**CITY OF ALBUQUERQUE
FIRE MARSHAL'S OFFICE**

PERMIT NUMBER: PERMIT-21-007055
PERMIT TYPE: PC 105.7.21 - Fire Site Plan Review
ISSUED BY: LOUIS III, Gilbert

ENGINEER'S SEAL RONALD R. BOHANNON P.E. #7868	THE WYMONT ALBUQUERQUE, NM FIRE ONE PLAN 5571 MIDWAY PARK PL NE ALBUQUERQUE, NEW MEXICO 87109 (505) 858-3100 www.tierrawestllc.com	DRAWN BY pm
		DATE 8-9-21
		DRAWING
		SHEET # FO-1
		JOB # 2021008

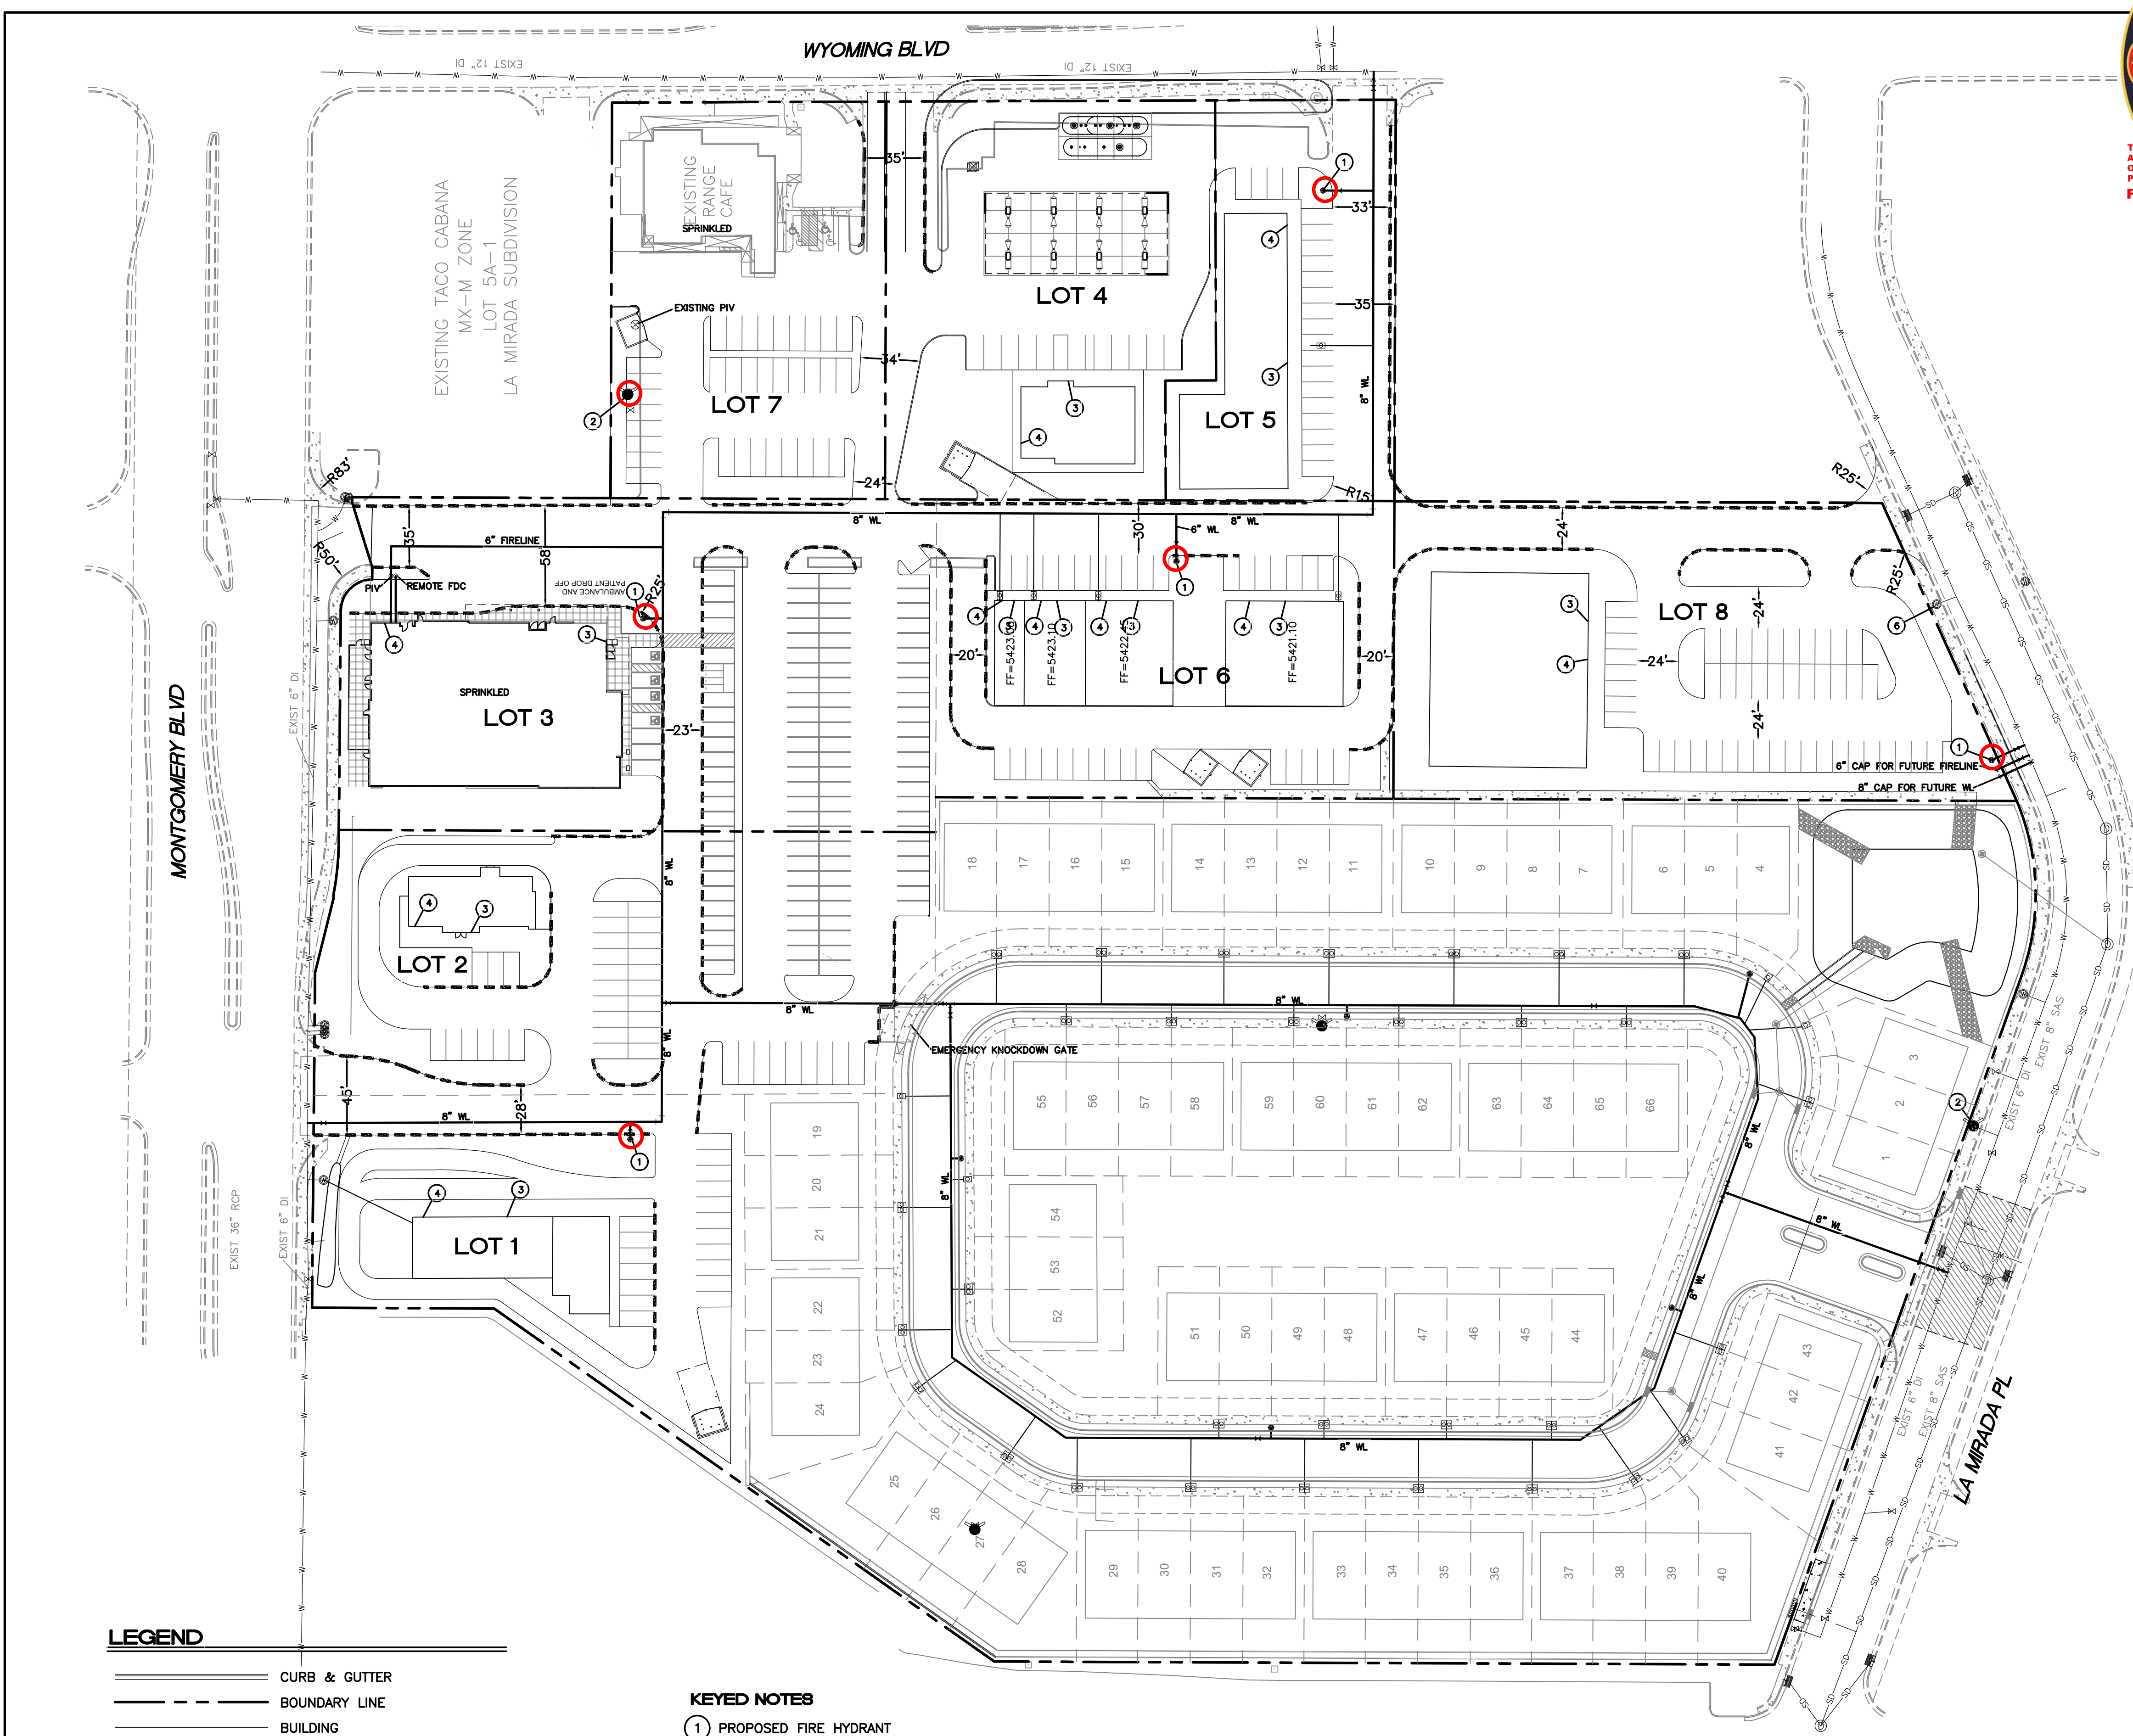
8/5/21 GL3 1051
INSPECTION REQUIRED, DISAPPROVED, LOT 3 SHOW FDC LOCATION ON
PLAN FDC SHALL BE LOCATED WITHIN 100 FEET OF HYDRANT, LOT 6 ACCESS
ROADS SHALL BE 20 FEET WIDE, UPLOAD PLANS INDIVIDUALLY, TURNING
RADIUS SHALL BE 28 FEET, PROVIDE ADDRESS
